Design Review Board Meeting
Tuesday, October 14, 2025 - 5:00 PM
AGENDA

Design Review Board
Tuesday, September 23, 2025 - 5:00 PM
MINUTES

PLANNING STAFF REPORT

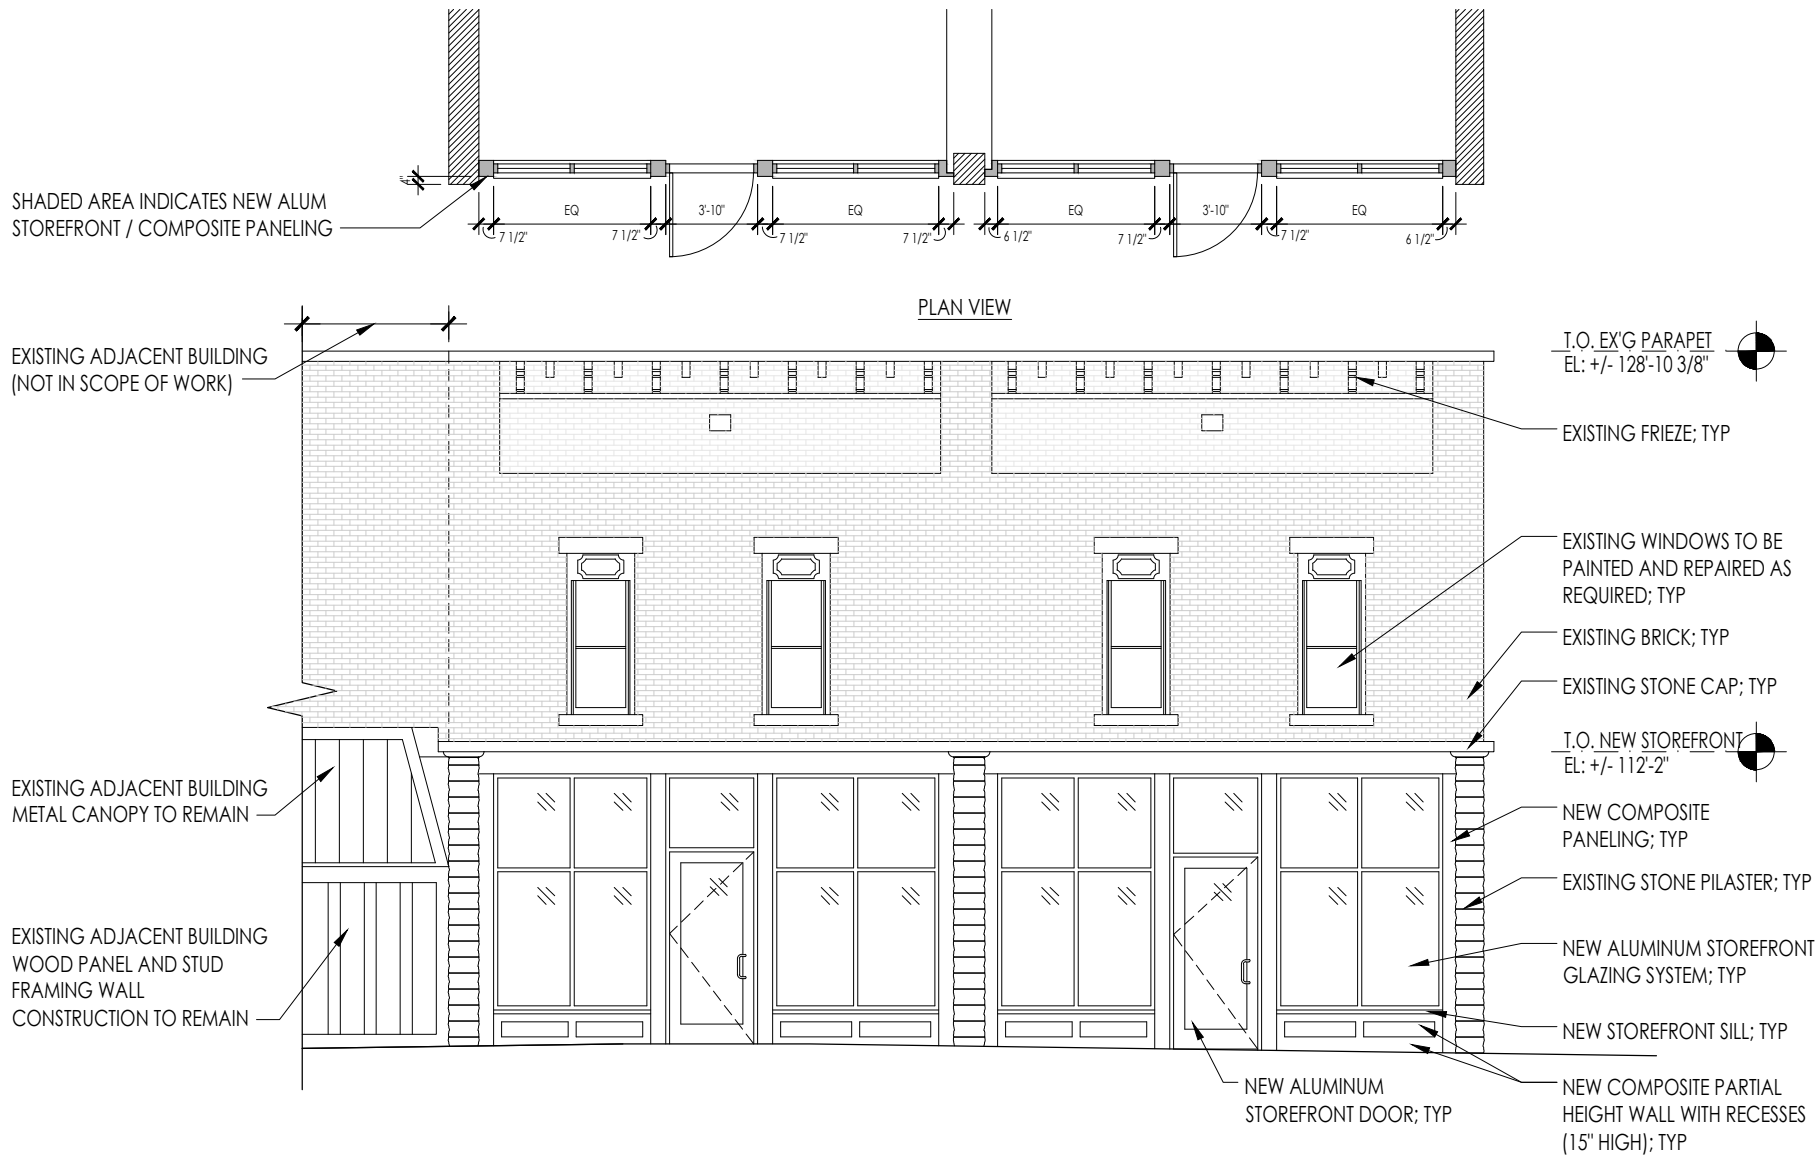
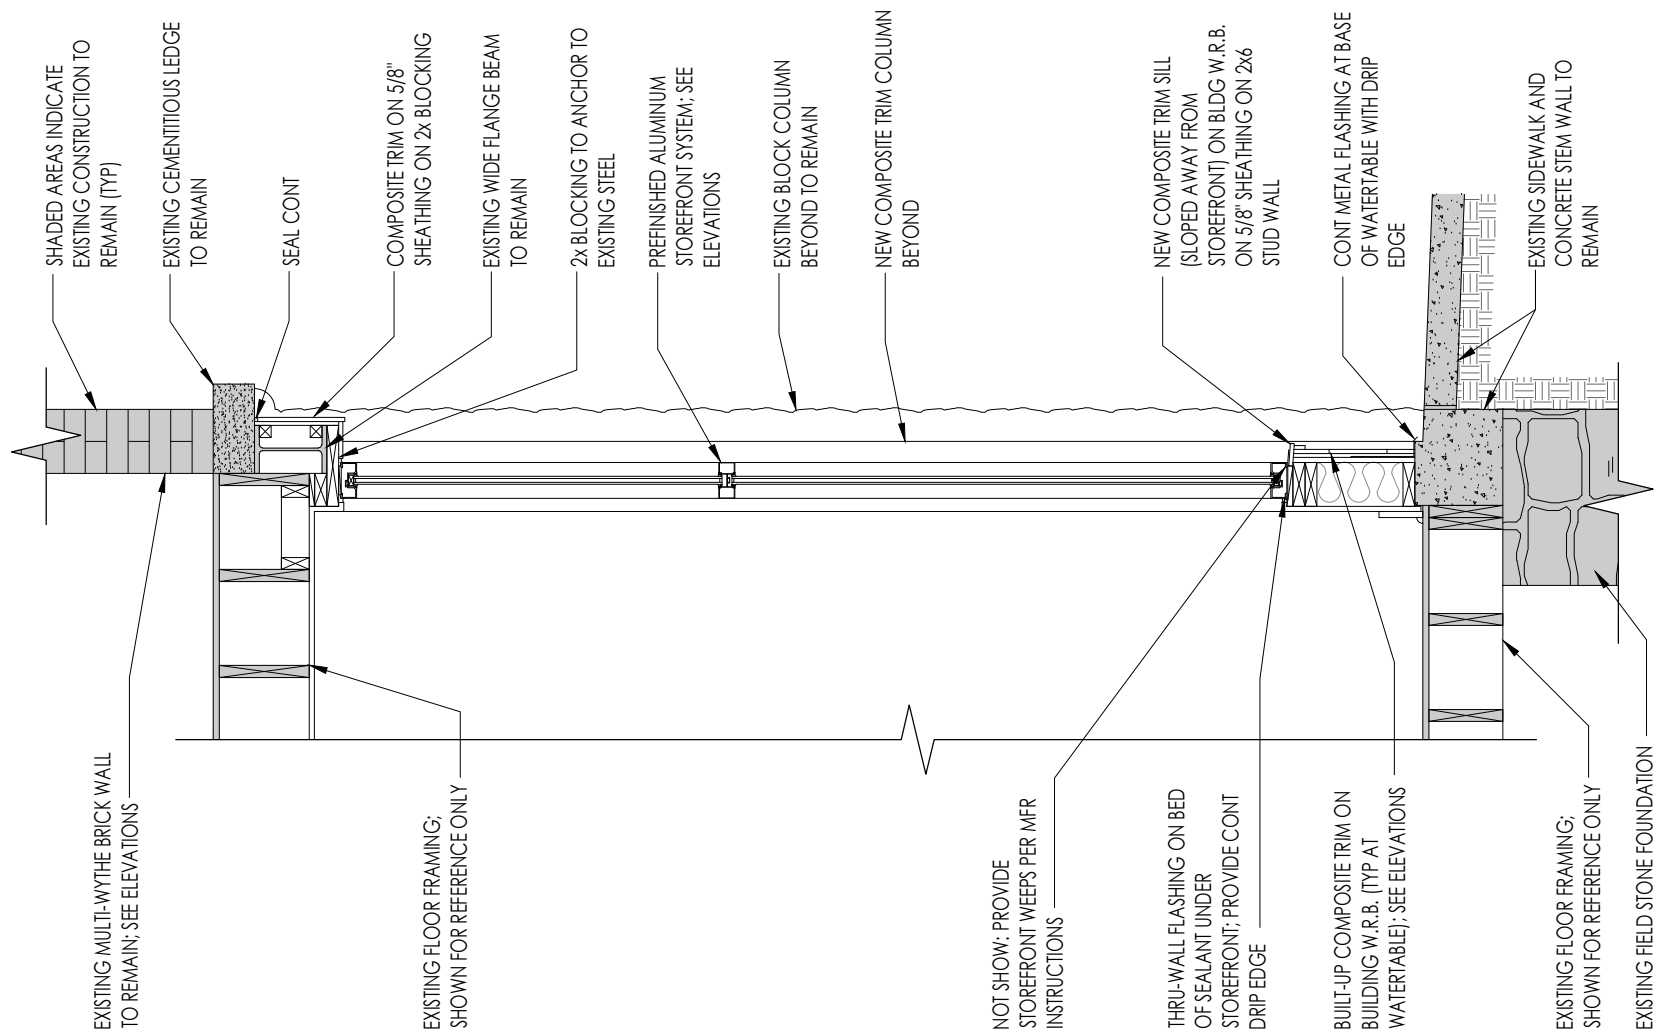
Page 63, Subsection 9(b)– Design Standards. The primary material that will be used to replace the materials removed is a storefront system that includes aluminum and glass. A concrete partial height wall will also be installed along the bottom of the storefront system. Concrete is not identified as a desirable material (although cement-based products are encouraged). The DRB can reference the "Required and Desirable Materials" list on page 64 of the adopted design guidelines for options to enhance the overall design, if desired. Existing brick/stone on the front façade will remain in place.

Reviewer comment: The proposal is to restore a storefront aesthetic to the existing building. The proposed alterations will restore large windows. Given the removal of original windows and details along the ground floor over time, this alteration will more closely align the building with the original form.

Reviewer Comment: As noted previously, the proposed alterations will return the large windows and front doors to the sidewalk. This proposal will return the majority of the character of this building that has been lost to previous alterations over time. The DRB should review the window replacements that have occurred on the northern façade of the building prior to this application being submitted.

Reviewer Comment: The proposed storefront system now includes details requested by the DRB and more closely aligns with the original details of the building.

HISTORIC PHOTO FOR REFERENCE

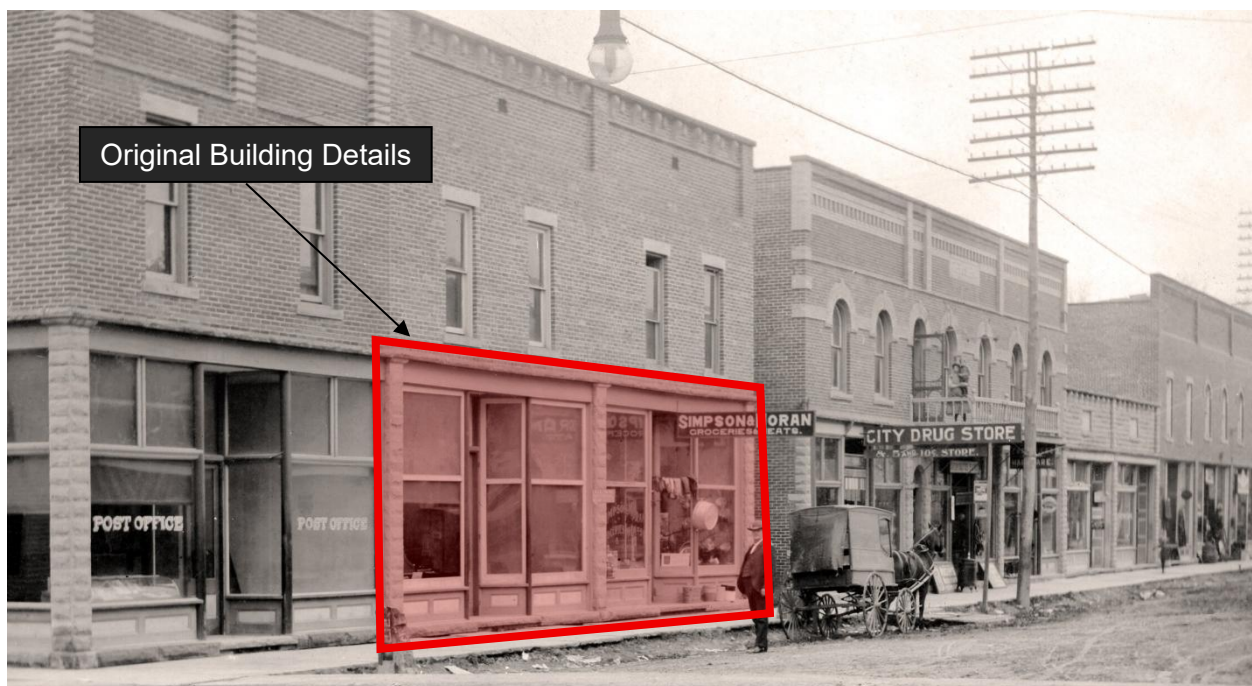
Reviewer Comment: The existing building has clear and reliable historic imagery to base changes on. The existing character of the building is not reflective of the original details and character. Including details that mimic the original will bring the structure into greatest compliance with the design guidelines.

Reviewer Comment: Many of the original details along the ground floor have been removed by previous alterations. The photo on page 3 illustrates the original ground-floor details on this structure.
